SHOP DRAWING REVIEW

| △ | | | |
|--|---|-----------------|-----------|
| GIRDER G51 | | | |
| VT 78 OVER MISSISQUOI BAY, BRIDGE NO. 2 | | | |
| CONTRACT NUMBER: | VT-04057-2 | DRAWING NUMBER: | 33 OF 112 |

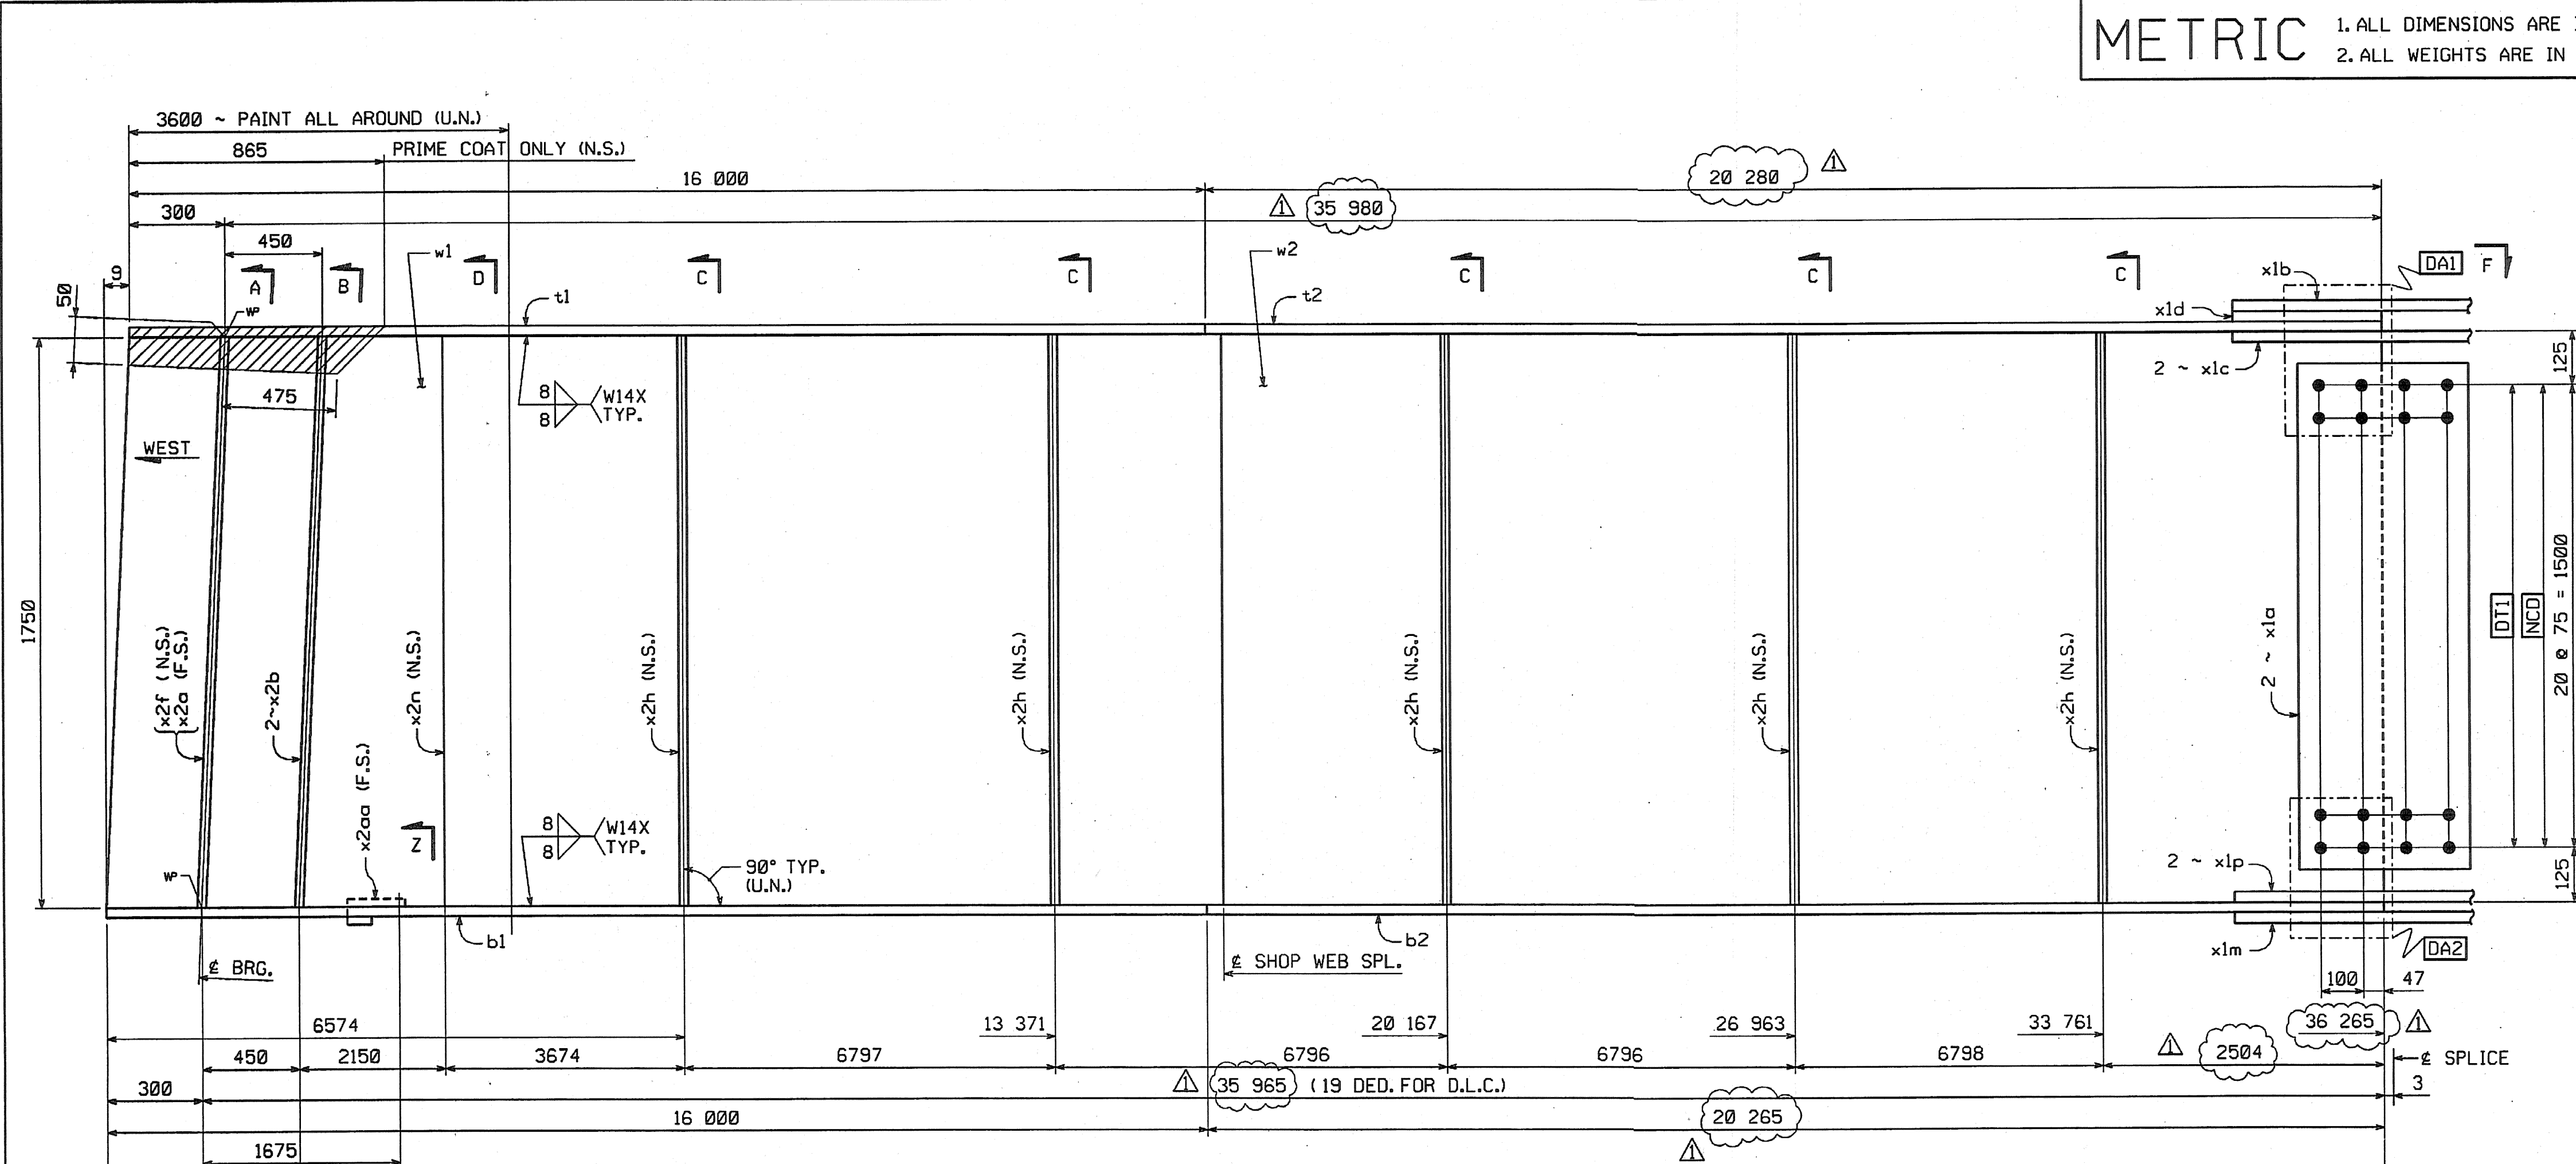
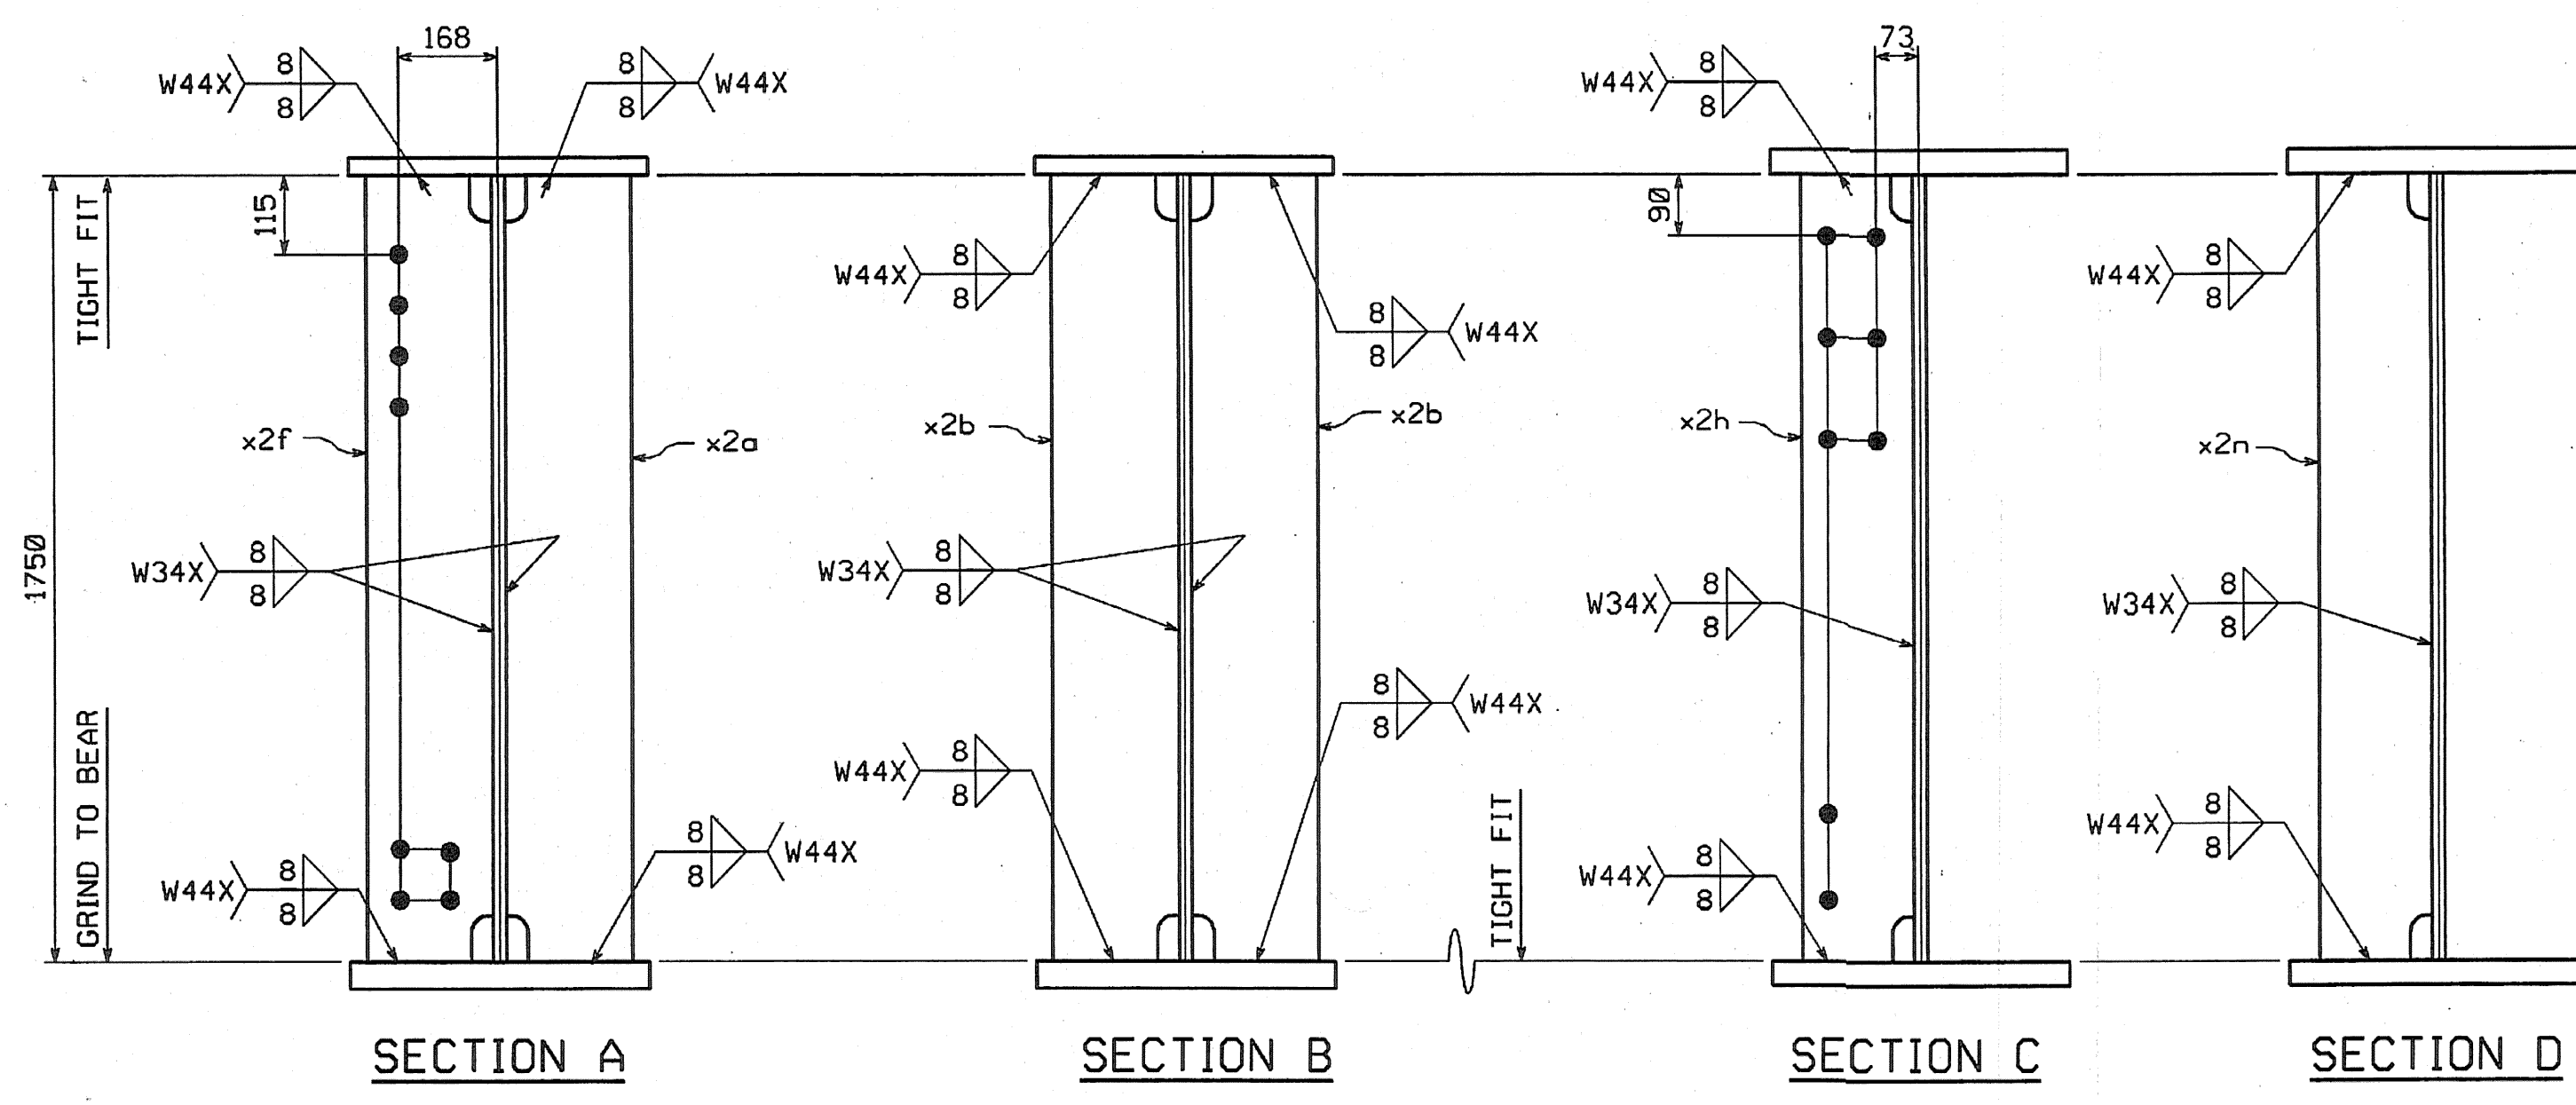
| △ | | | |
|--|---|-----------------|-----------|
| △ | INCREASE LENGTHS TO SATISFY REQUIREMENTS FOR LENGTH & MEAN TEMPERATURE OF 45°F. | JSA | 9/17/04 |
